# MEMORANDUM

## **B1 - MEANS OF ESCAPE OBSERVATIONS**

PREMISES: Grenfell Tower, Grenfell Road  
APP No: Preliminary  
SUBMISSION No: Preliminary (P2)  
DRAWING No:  
Please also refer to marked up plan P2.

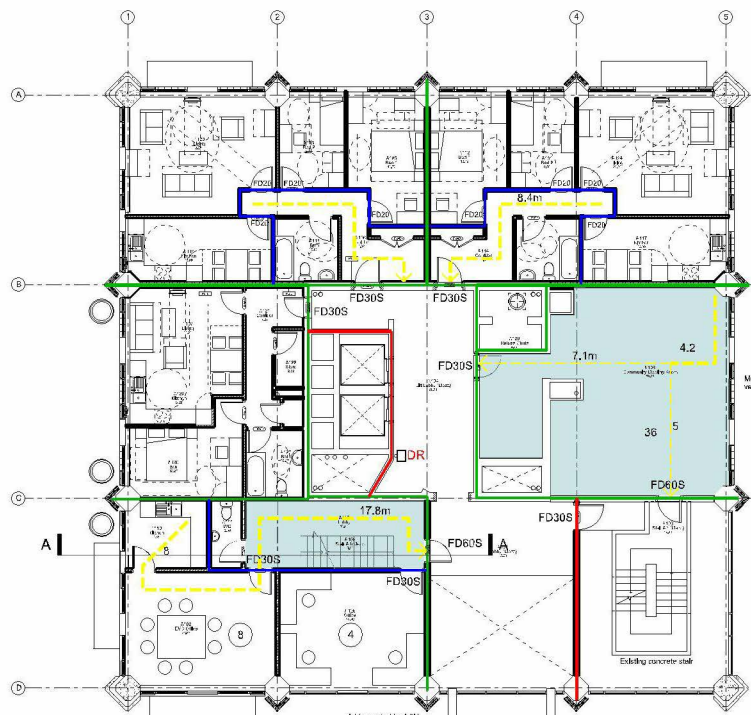
Due to the reconfiguration of the stair and lobbies, some riser shafts open directly in to the stairway. This arrangement should be avoided. Is access to the risers necessary at this level (see marked up plans with symbol 'A' for these areas). Access to lobbies is acceptable as identified by symbol 'B'.

1 MEZZANINE  
1:100

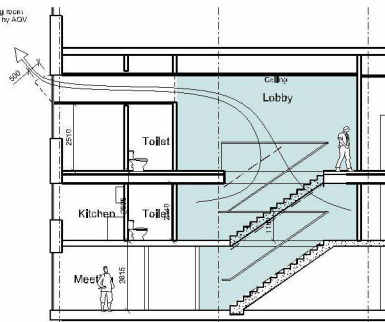
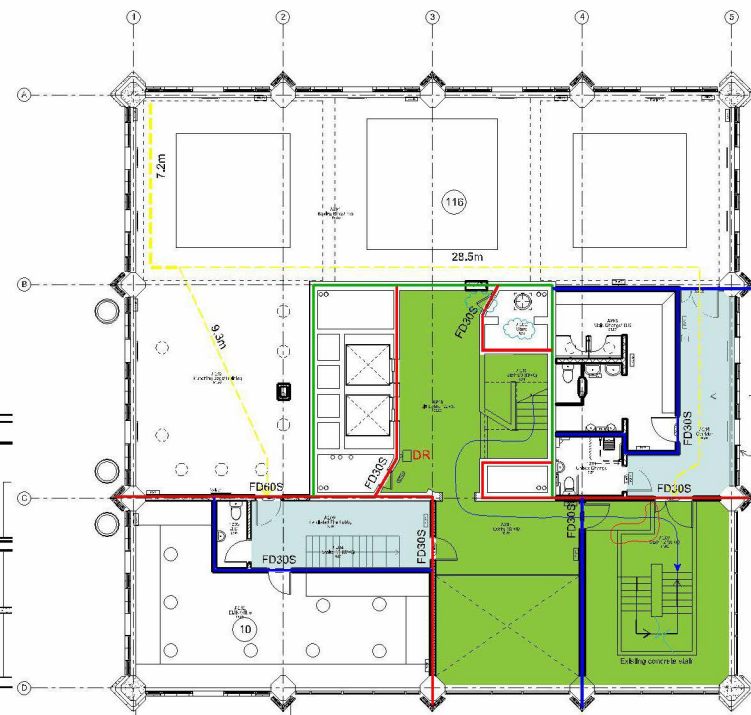
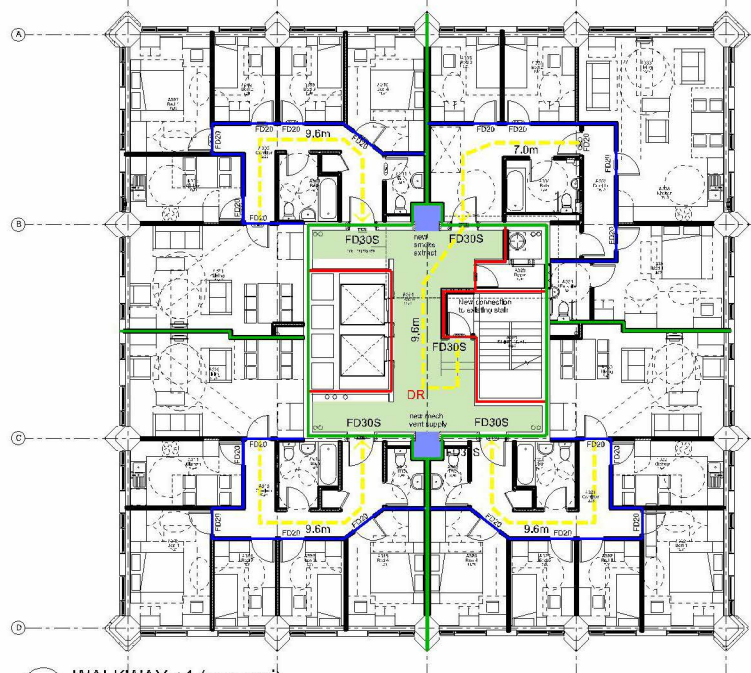
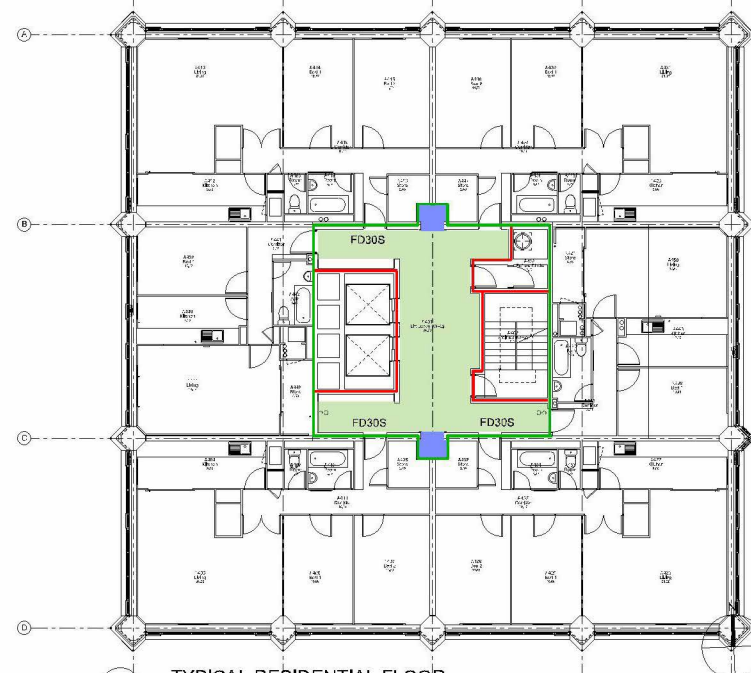
Is this the route from the residential stair to the street?

FIRE ACCESS PLAN

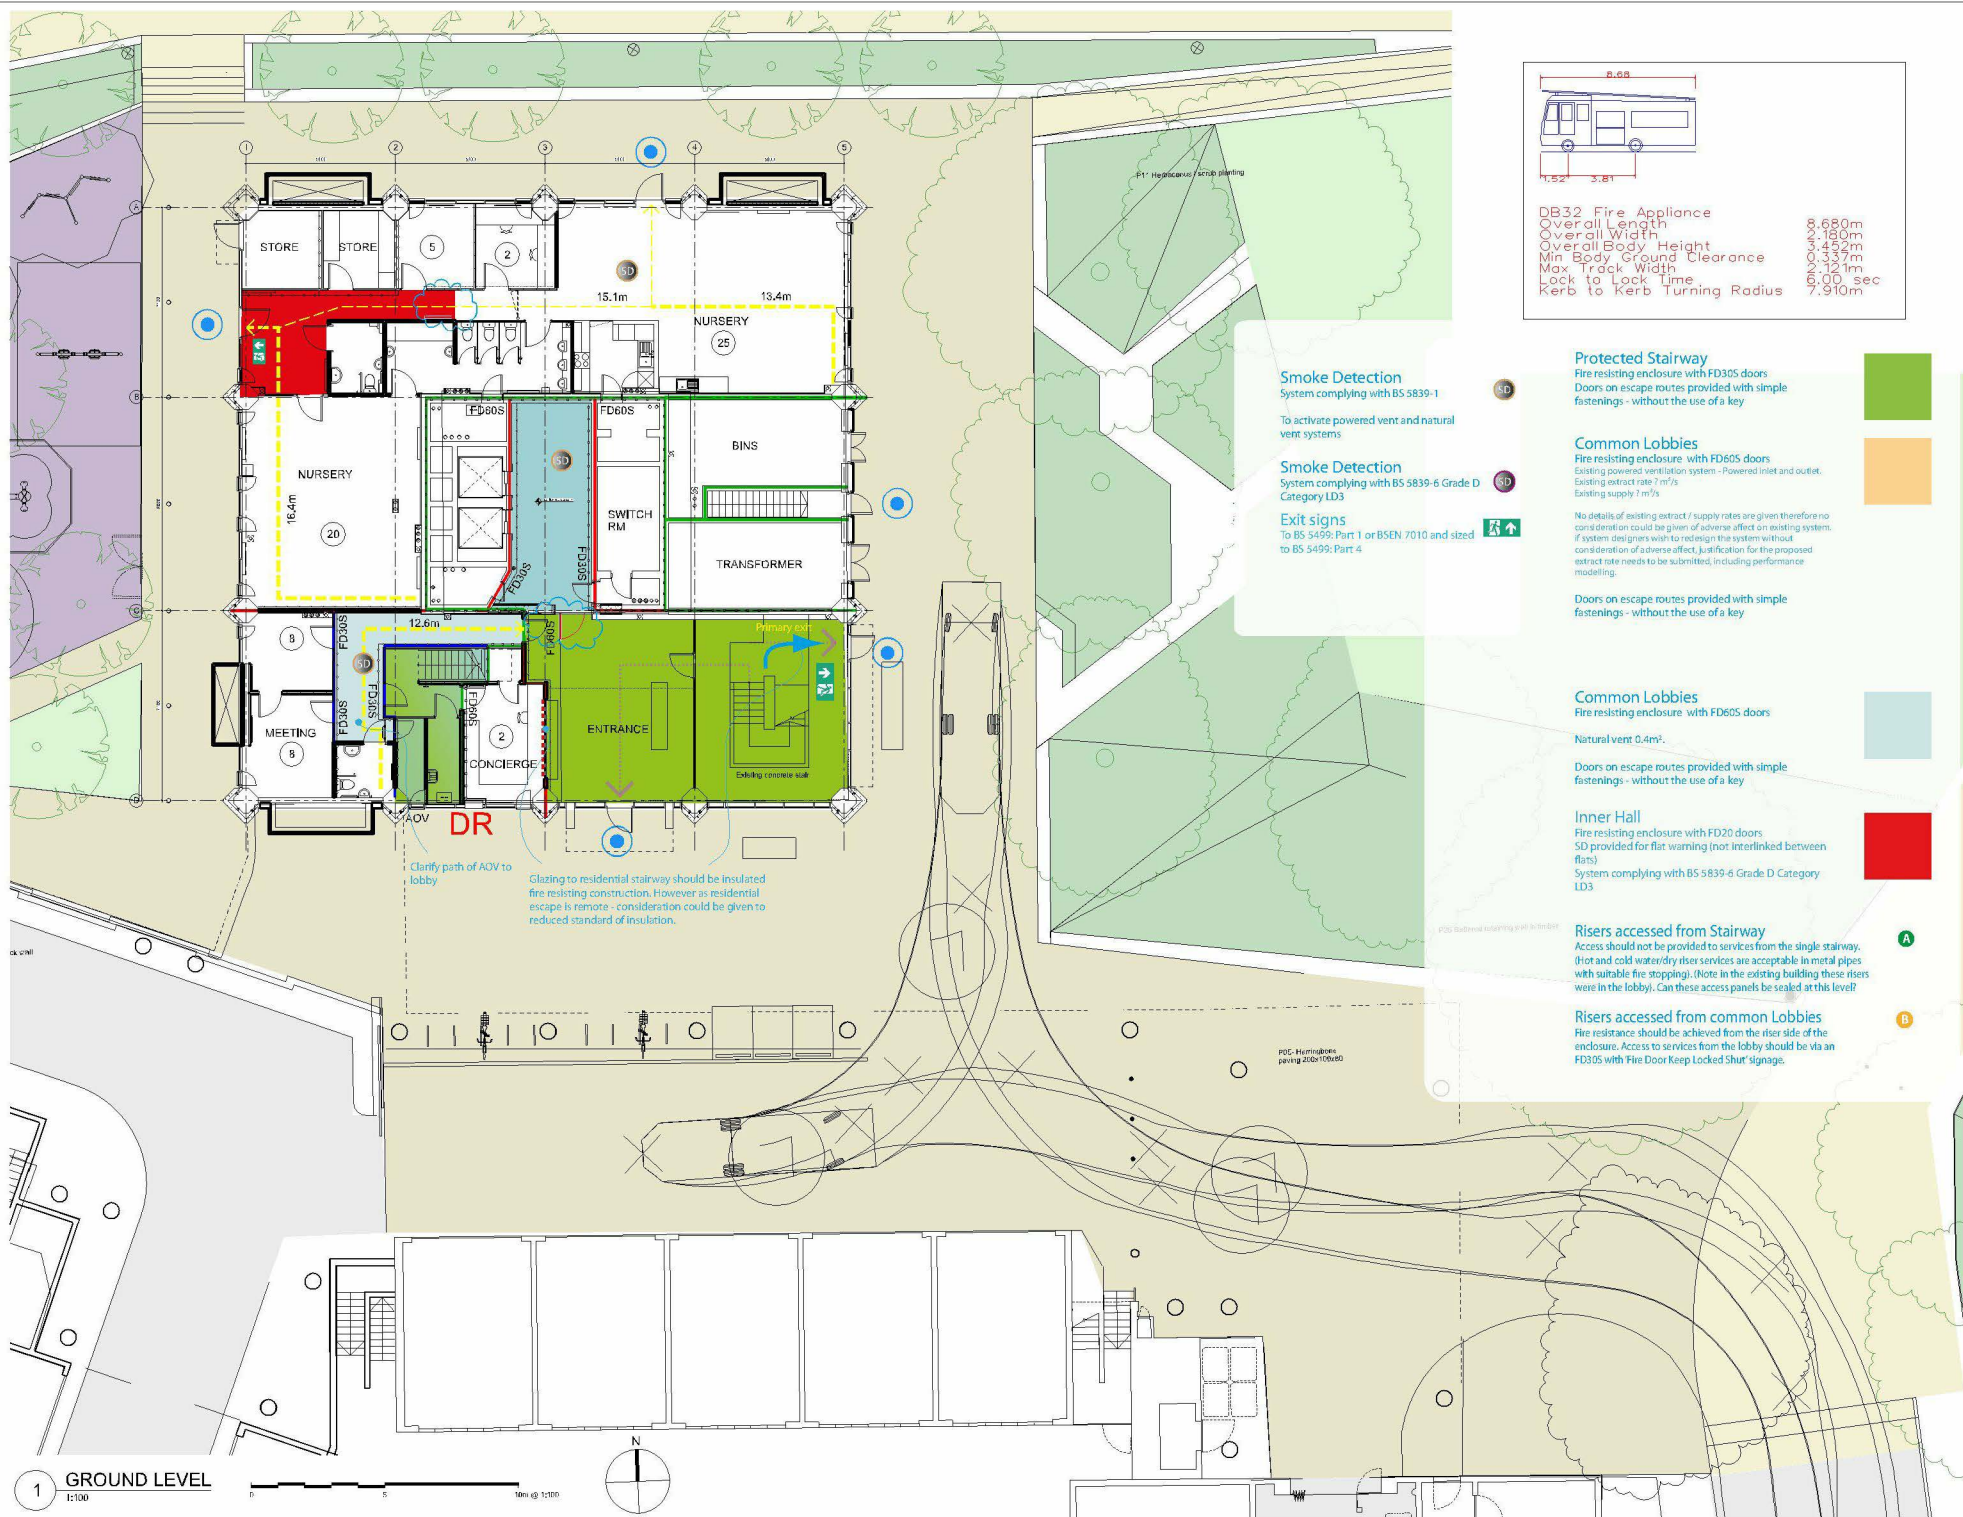
For further comments see marked up plans.
